17-096ARB-MPR – 113 S. HIGH STREET

Request for a proposed $\pm 3,300$ -square-foot two-story office building and associated site improvements; parking plan; and fee-in-lieu of open space.

ART Recommendation

ART recommends approval of 4 Waivers; Fee-in-lieu of open space; Parking Plan and a Minor Project Review with 4 conditions.

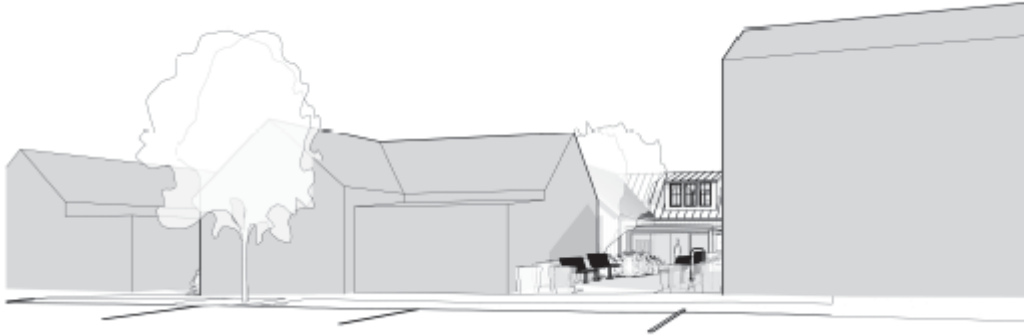
The proposed building is one and one-half stories with a gable roof line and dormers at the east and west elevations. A covered entrance is proposed at the east building entry at a pitch of 0.5:12 where a pitch greater than 3:12 is required on roofs of dormers, porches, balconies, or other minor roofs. The reduced pitch provides a functional covered entrance and maintains a clean line for the contemporary aesthetic of the building. Code requires that all principal entrances be at a pedestrian scale, effectively address the street and be given prominence on the façade through the use of architectural features. A waiver is requested to the northeast and northwest entrances, because they do not address South High Street and Mill Lane, respectively. Due to the building set back behind the existing principal structure, the northeast and northwest entrances are set back from the two streets. In order to accommodate the parking area and reduce the impact on the adjoining property owners, the building was located to the center of the lot.

Materials include shiplap cedar wood siding in dark gray, split-faced concrete masonry base, with horizontal wood accents. Split-faced concrete masonry is not a

permitted material within the Historic District. A condition of approval requires that the applicant replace the proposed split-faced block on the lower portion of the proposed building with brick or stone. The shiplap siding and a cultured stone fireplace are contemporary interpretations of wood and stone that have been used in other new construction in the area. A black standing seam metal roof will match the existing building's roof. The east elevation features a prominent stone chimney and the west elevation has a two-story window at the gable end. Code requires façades be designed to follow the stories of the building with fenestration organized along and occupying each floor. A waiver is requested to allow for the gabled portion of the west elevation to feature a large window which spans the first and second stories. The design of the two-story window adds to the transparency requirement and creates a residential aesthetic which is generally more complementary in this part of the Historic District.

The rhythm of the openings in the proposed building is consistent with that of nearby buildings. Additionally, the proposal is for a cottage-commercial building, with general office uses in the ground story and half story. These uses and the style of building proposed will typically have a lower window to wall ratio than retail or other commercial uses, due to the need for privacy associated with these uses. The window to wall ratio proposed is also appropriate to the style of architecture proposed. As proposed, an administrative departure would be required for the non-street side transparency on the south elevation to allow for $\pm 14\%$ transparency where 15% is required. Street-facing façades require a minimum of 25% transparency. The applicant is requesting a waiver to allow for $\pm 10\%$ transparency on the west elevation (Mill Lane).

- 1) That the applicant replaces the proposed split face block on the lower portion of the proposed building with brick or stone.
- 2) That the applicant shall pay a fee-in-lieu of open space prior to building permit approval.
- 3) That the applicant provides required bicycle parking on site.
- 4) Should any archeological resources be identified during excavation, the applicant shall make a reasonable effort to record, protect, and preserve these resources.
